# Remedial Investigation Report for the Lee Acres Landfill Response to EPA Region VI Comments

January 1993

**United States Department of the Interior  
Bureau of Land Management  
1235 N. La Plata Highway  
Farmington, New Mexico 87401**

**Prepared by  
Roy F. Weston, Inc.  
6501 Americas Parkway NE, Suite 800  
Albuquerque, New Mexico 87110  
(505) 884-5050**

26. Section 3.1.1.1, Page 2, Paragraph 2

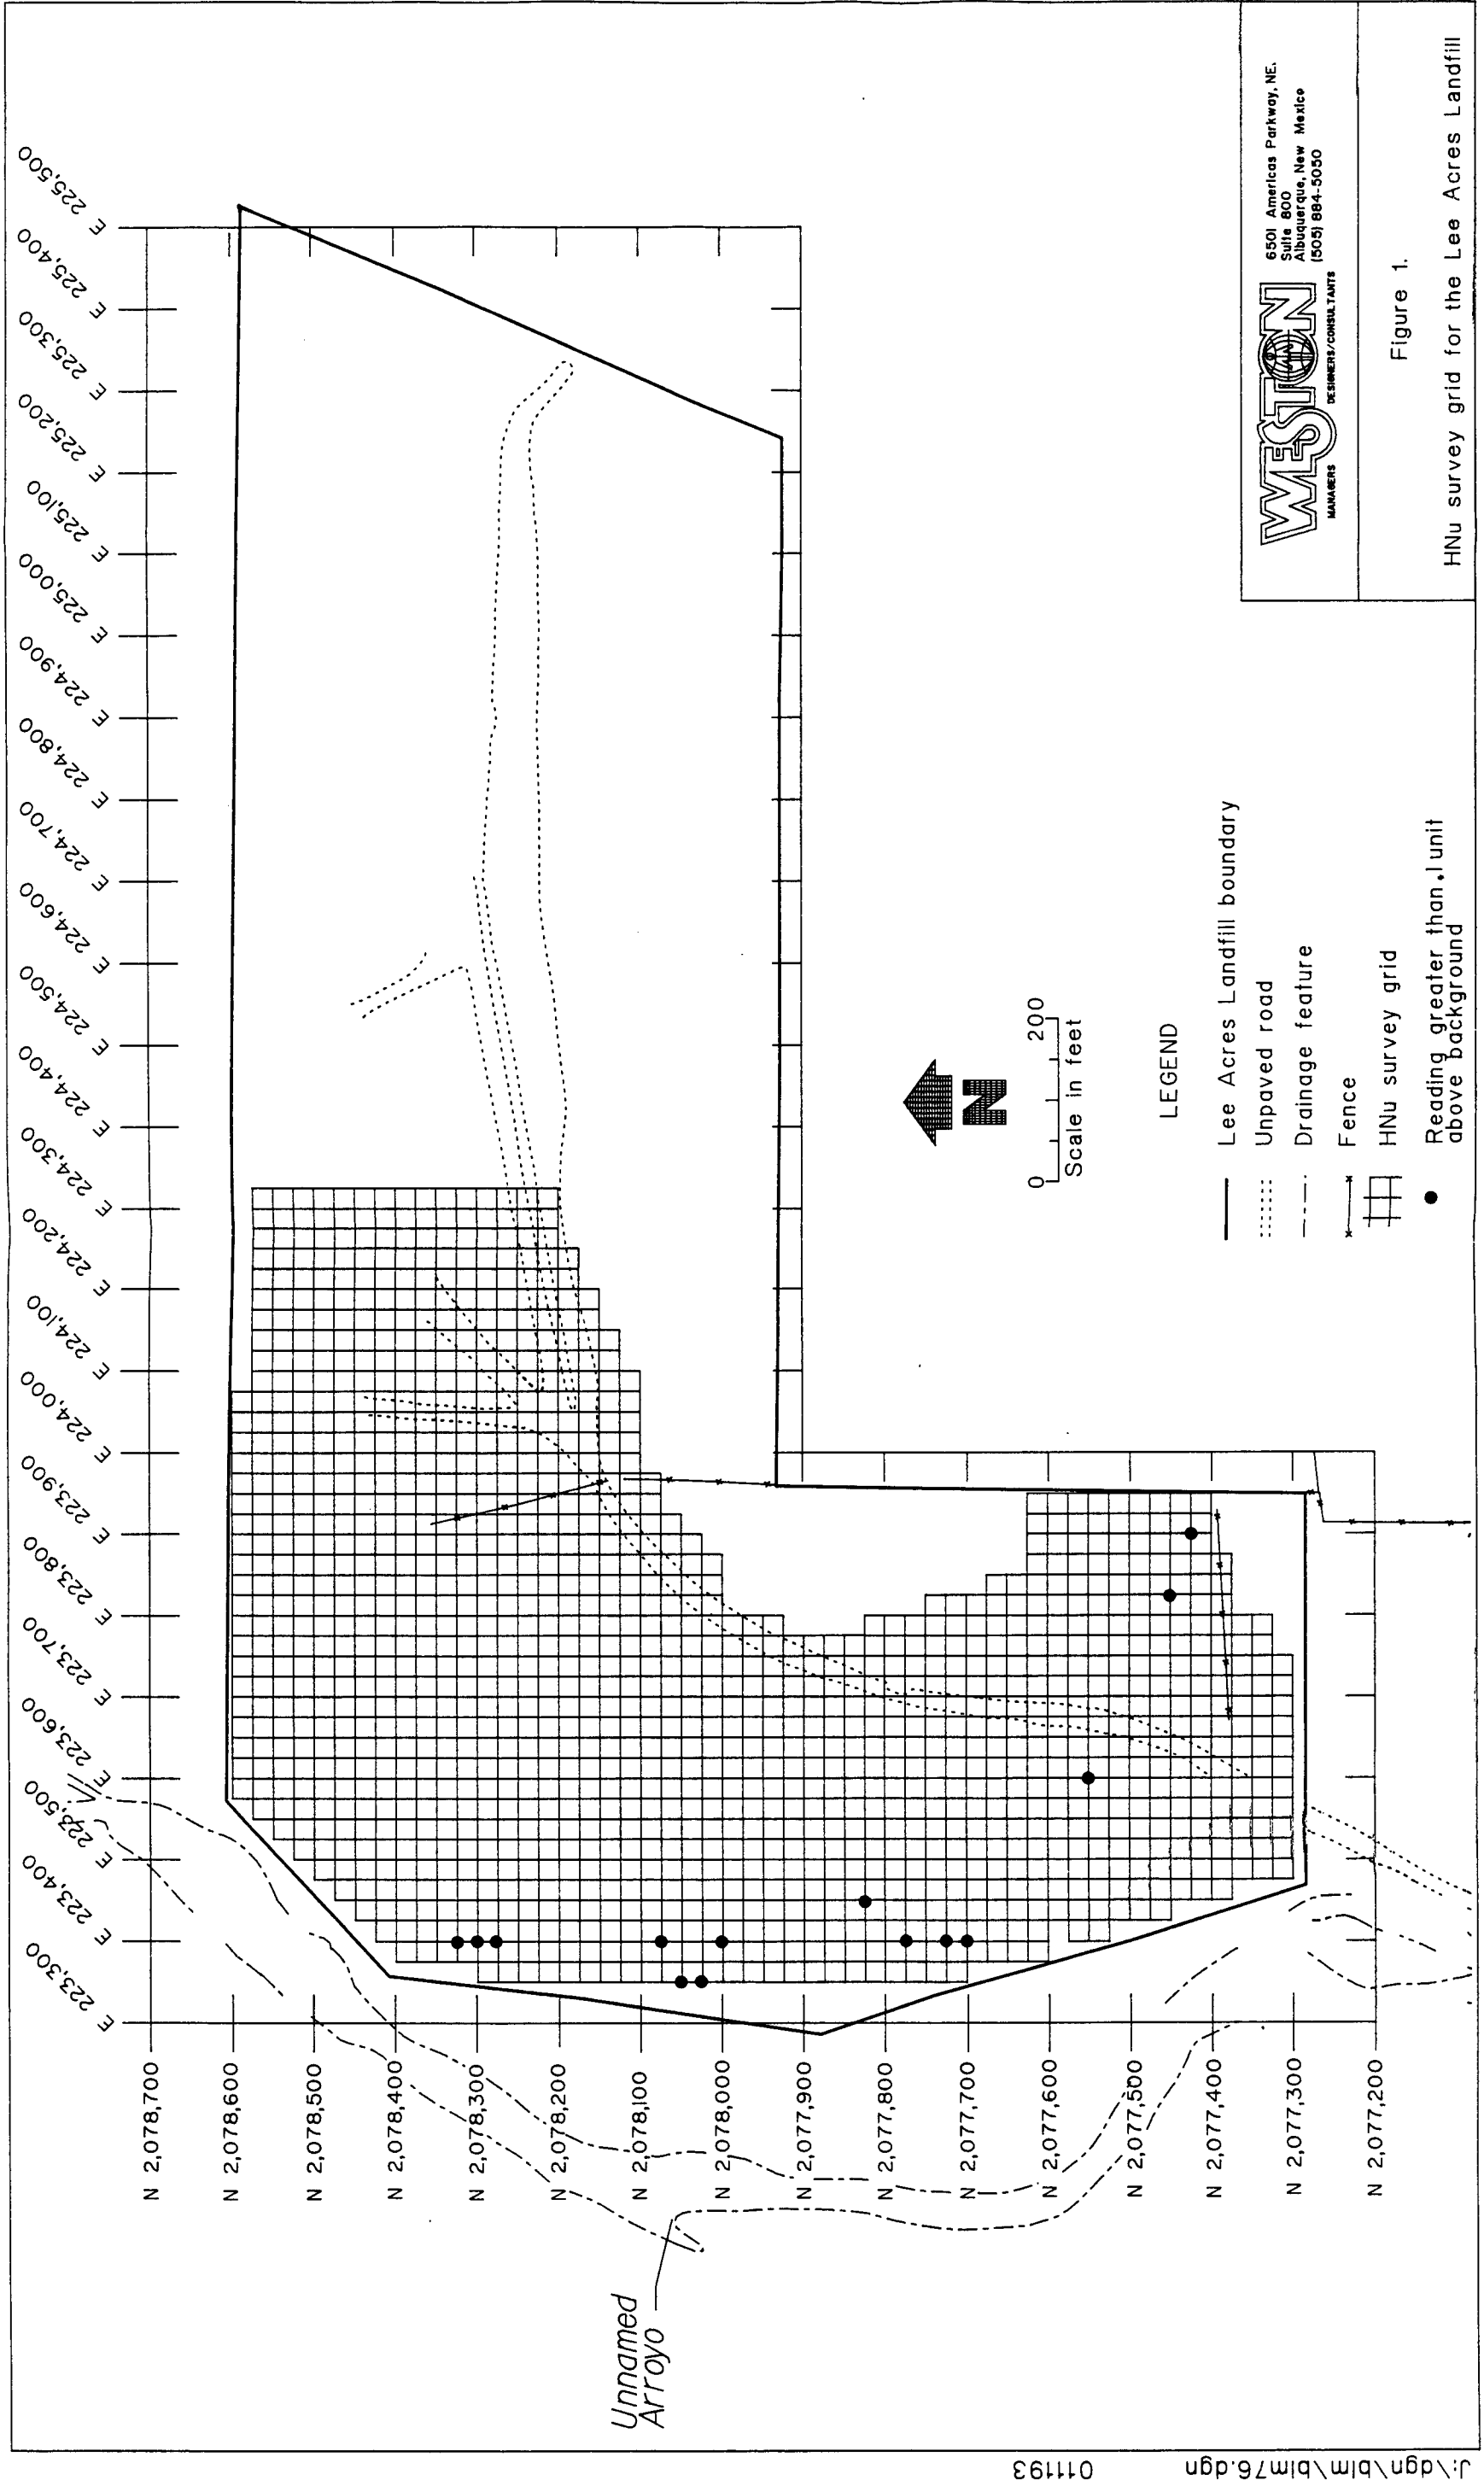
It is stated that only one HNu reading, out of about 1,300 readings, was above background concentrations. However, no discussion of the background concentrations, locations of the readings, or HNu QA/QC information was provided for review. If the results were used to refine or scope further investigation activities, provide that information. Discuss the significance of the HNu survey investigation and its purpose and results.

*Figure 1 shows the area of the landfill where the survey was performed. The HNu readings obtained during the investigation are presented in Table 1 in Appendix E. Table 1 includes location (northing and easting), background reading, and reading just above the soil (if different than background). Background refers to the "zero" setting of the instrument, which is normally set between 0.5 and 1.0 units in order to ensure the instrument is responsive. Thirteen readings ranged from 0.2 to 0.8 units above background. The one reading referred to in the text was 5.8 units, with a background reading of 0.6 units. The QA/QC information for the HNu investigation is summarized in Table 2 of Appendix E and provides all calibration information. The results of the HNu survey were used to determine locations for the air canister sampling program. A complete discussion of the purpose and results of the HNu survey will be provided in the revised RI Report. Additionally, Appendix E will be included in the revised report.*
